Environmental Impact Statement on the Construction and Operation of a Proposed Mixed Oxide Fuel Fabrication Facility at the Savannah River Site, South Carolina

Final Report

**U.S. Nuclear Regulatory Commission
Office of Nuclear Material Safety and Safeguards
Washington, DC 20555-0001**

Appendix J includes a summary of the comments and responses received on the DEIS. Ninety-four commenters submitted about 750 comments on the DEIS. Appendix J also identifies changes in the FEIS text based on the comments and revised accident analyses from new design information for the WSB provided by DCS since publication of the DEIS.

Figure 3.8. Roadways in the vicinity of the SRS.

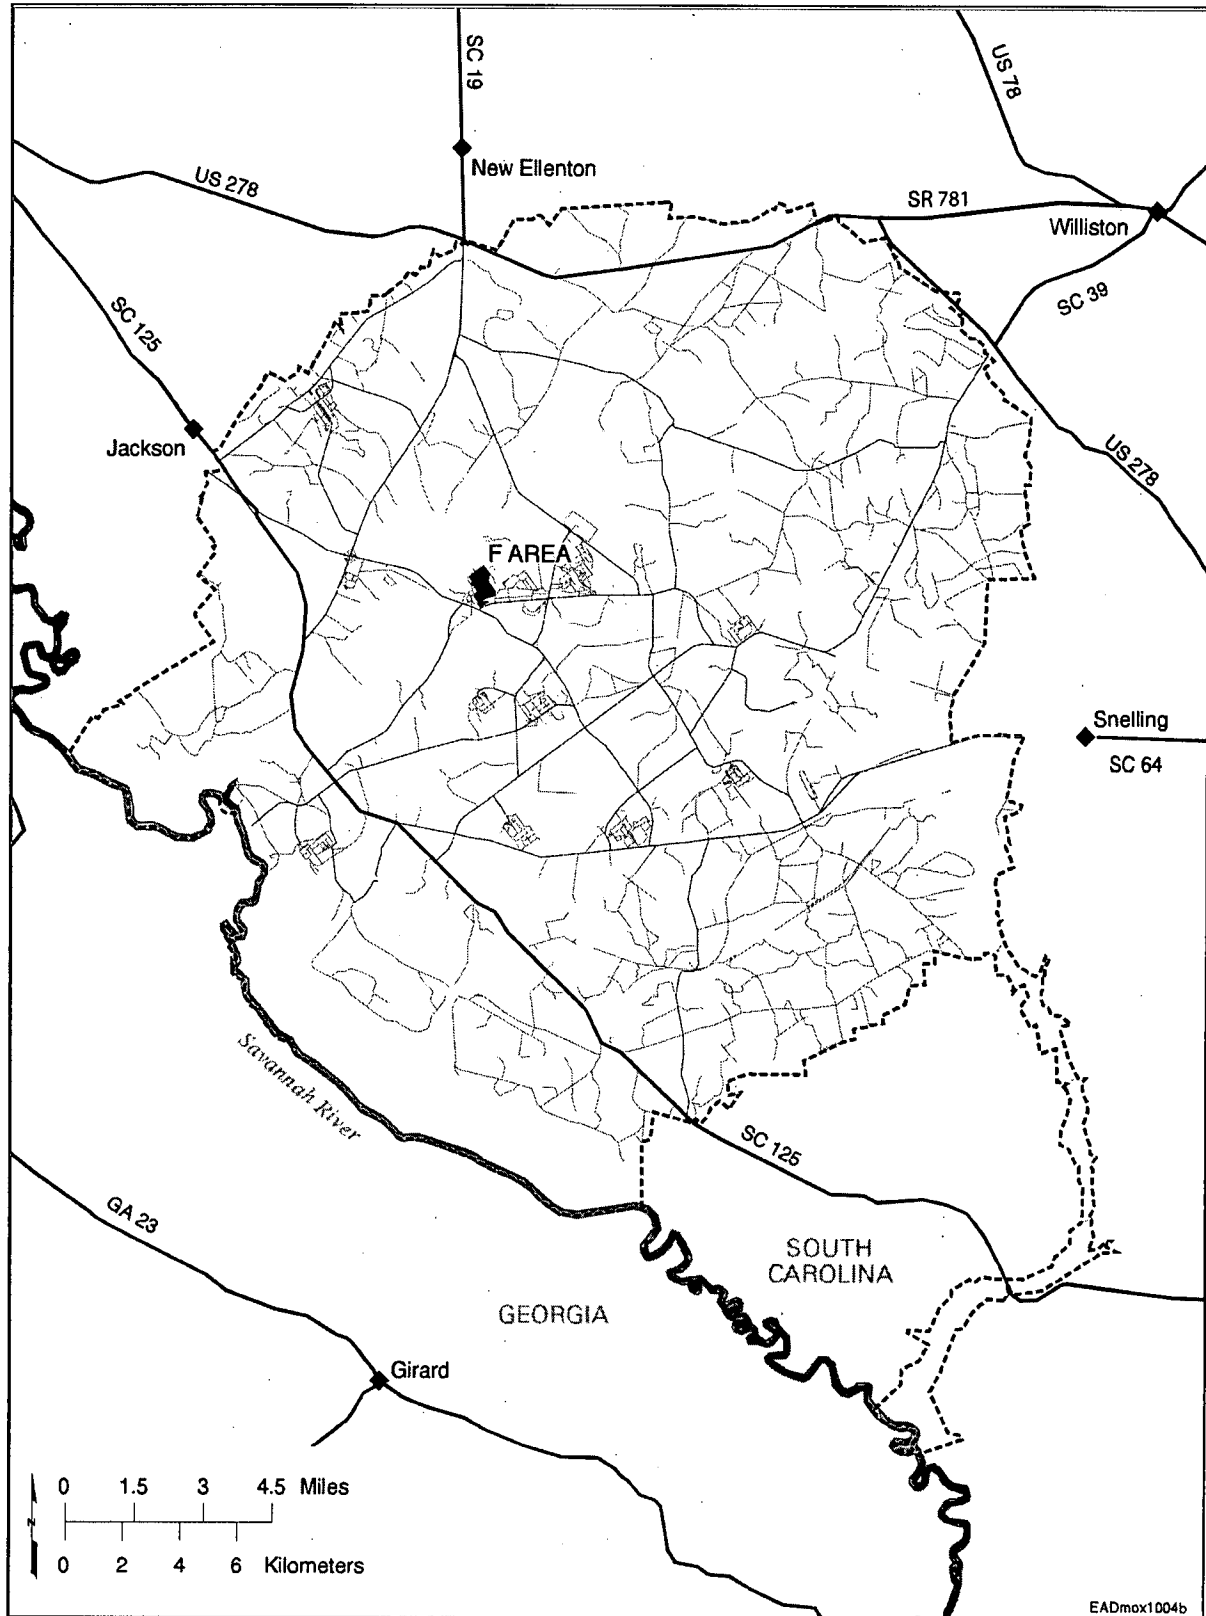
Comment: State Route 781 is not shown in either Figure 3.1 or 3.8, as indicated in the text. Also, the text refers to State Routes (SRs), while the Figure 3.8 refers to "SC."

3.11.6	Page 3-61, line 18	The 2002 column of the table does not have a source footnoted (as do the 1990 and 2000 columns). State Route 781 is not shown in either Figure 3.1 or 3.8, as indicated in the text. Also, the text refers to State Routes (SRs), while the Figure 3.8 refers to "SC."

Response: State Route 781 has been added to Figure 3.8, and the text and figure in the FEIS have been made consistent with each other.
